PROJECT: Mayfair Place
7368 & 7388 Sandborne Avenue, New Westminster, BC

SUBJECT: Follow-up End-of-Warranty-Period Review

**END OF WARRANTY REVIEW
MAYFAIR PLACE
7368 & 7388 SANDBORNE AVENUE,
BURNABY, B.C.**

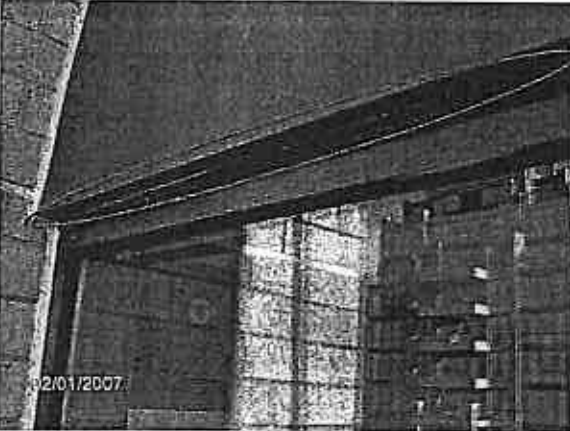
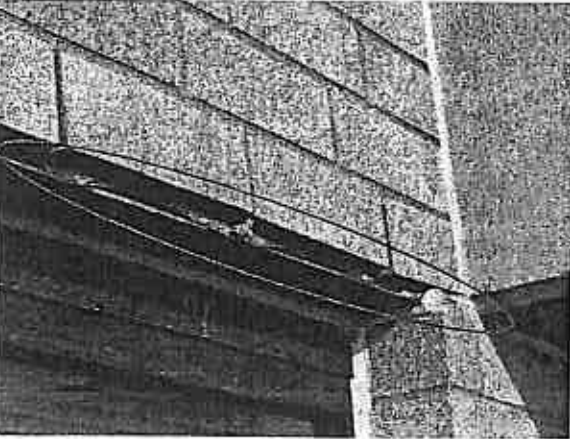
Previously Observed Deficiency	Current Observations
Paint peeling on horizontal concrete surfaces, some concrete window sills; blistering balcony coating	Still frequently observed [Photograph 1]
Blueskin exposed	Still frequently observed [Photograph 2]
Brick mortar projecting past shelf angle; mortar droppings in operable windows sashes (upper and lower)	Still frequently observed [Photograph 3]
Concrete crack, voids, spalling; cold-joint efflorescence	Observed more frequently than in previous EWOR [Photograph 4]
Vents with improper sealant / mortar; plugged dryer vents; missing vent cover	Still frequently observed [Photograph 5]
Scuppers flush instead of projecting by 2 inches, negatively sloped, vegetation growing	Still frequently observed [Photograph 6]
Sealant failures, missing at pre-cast concrete sill or interface w/ brick	Still frequently observed [Photograph 7 & 8]

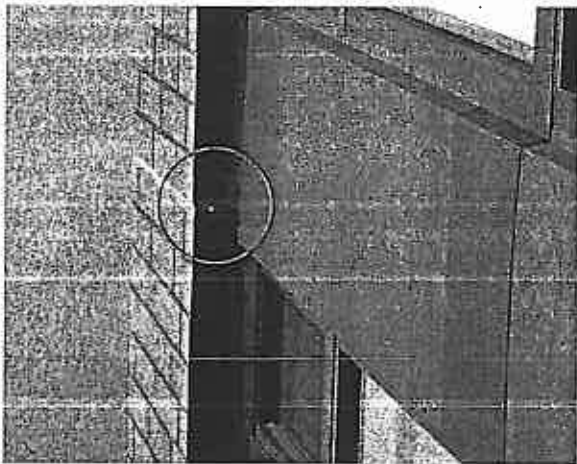
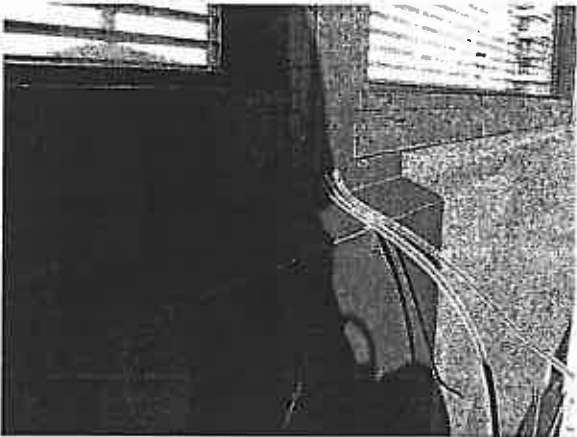
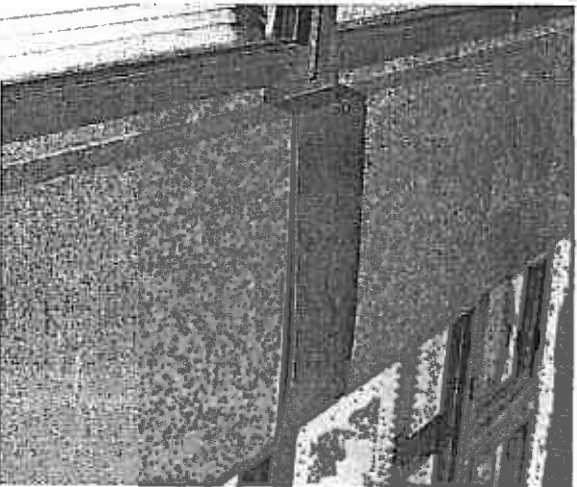
- Exposed waterproofing membrane at the roof. [Photograph 15]
- More concrete cracking and efflorescence than previously observed on both towers and the pool building.

- Corrosion of brick shelf angles visible on painted surface. Shelf angle ends protruding from the wall. [Photograph 16]
- Mohair gaskets slipping out from the window frames, which decreases the air tightness of the windows. A large number of windows are affected. [Photograph 17]

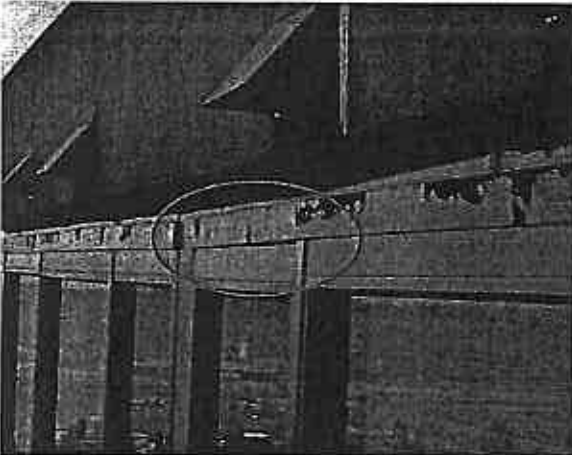
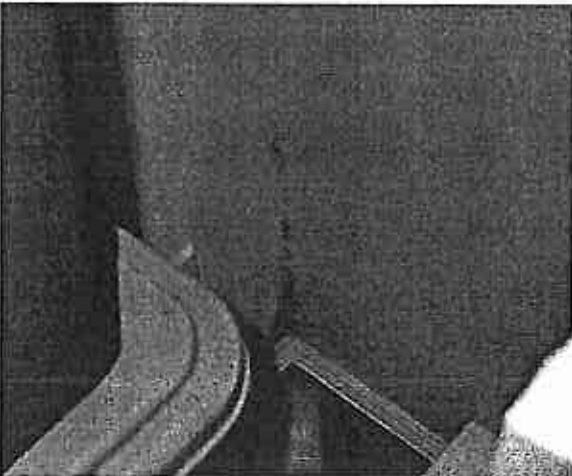
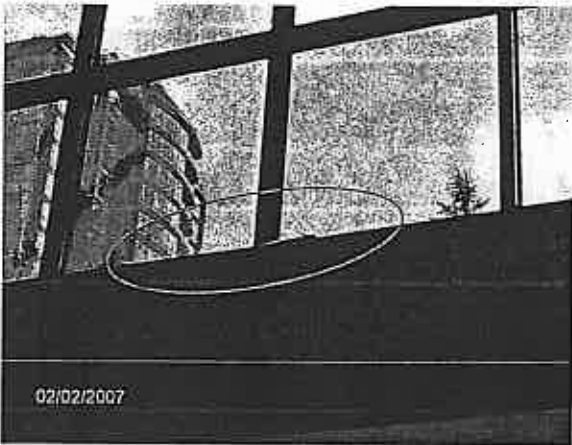
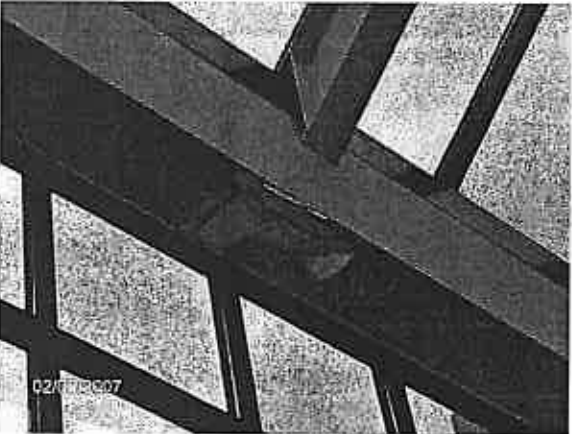
- Splice panels are loose and not caulked on the metal slab covers. [Photograph 18]
- Missing balcony scupper at Suite 203, Tower 1. Water pools on the balcony because the scupper acts as the only drain for the balcony. [Photograph 19]

- Head of window frame does not rest inside of the deflection channel. [Photograph 20]
- Tower 1, Suite 207: at-grade water ingress causing wood laminate flooring swelling as well as mould at the corner of the walls and window stools. [Photograph 21]

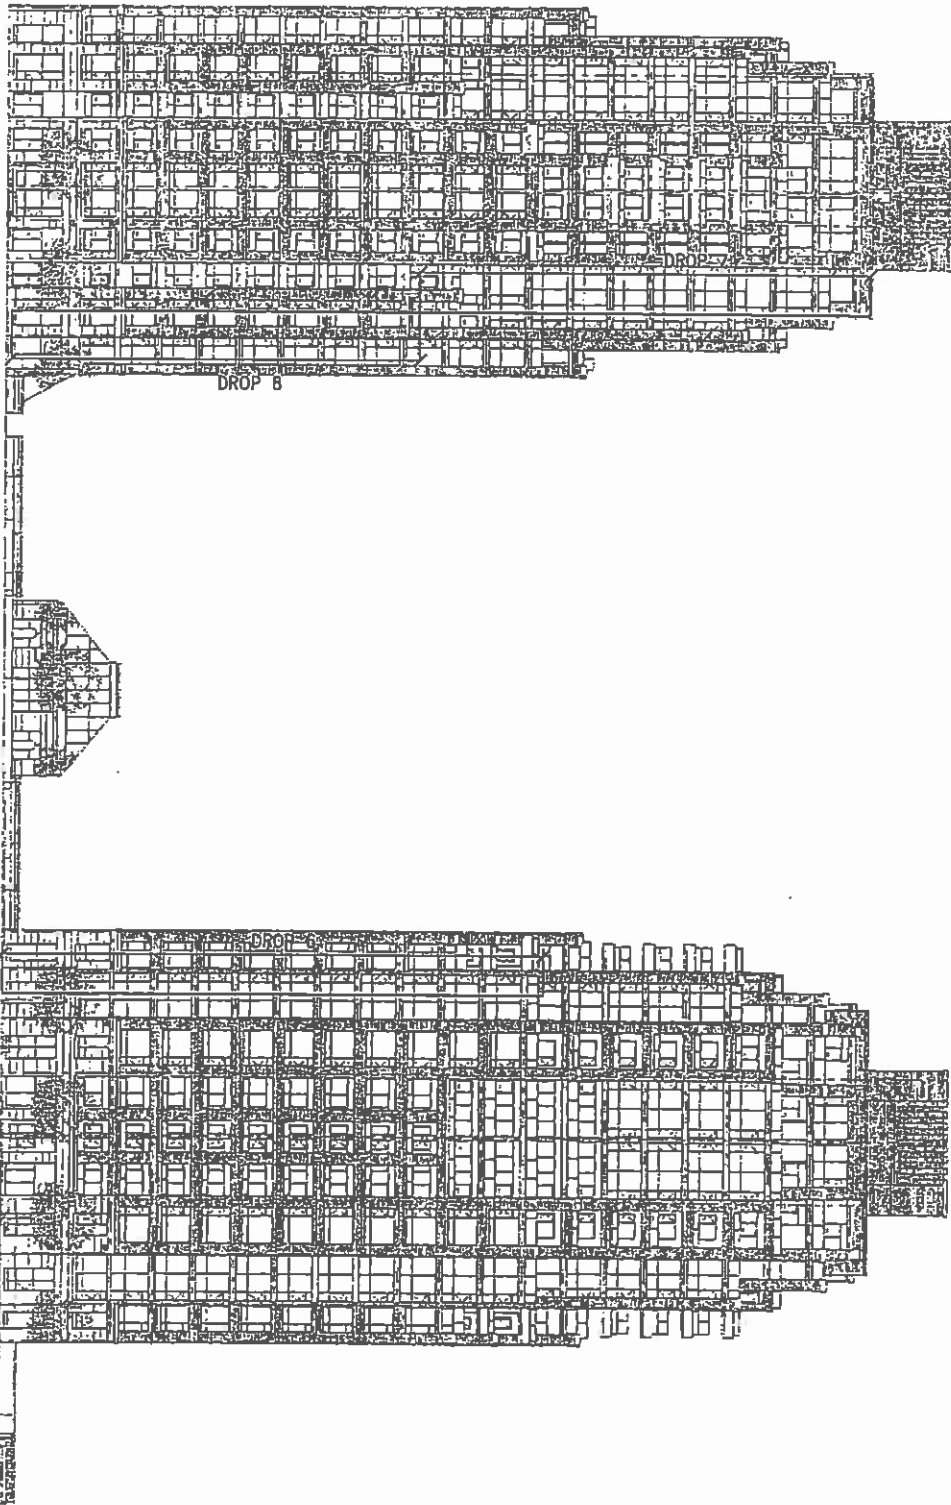
resistant drywall (Photo 69). It is not possible to verify if the wall sheathing was Wonder Board or moisture resistant drywall, as specified on the drawings, without removal of the tiles in the shower stall.

- **Rectify deficiencies related to the problems at the window stools.**
- **Provide continuity of the waterproof membrane at the shower stall bases and grouting to prevent water ingress into the slab.**
- **Repair delaminated tiles and missing grout.**
- **Repair all cracks in the drywall.**
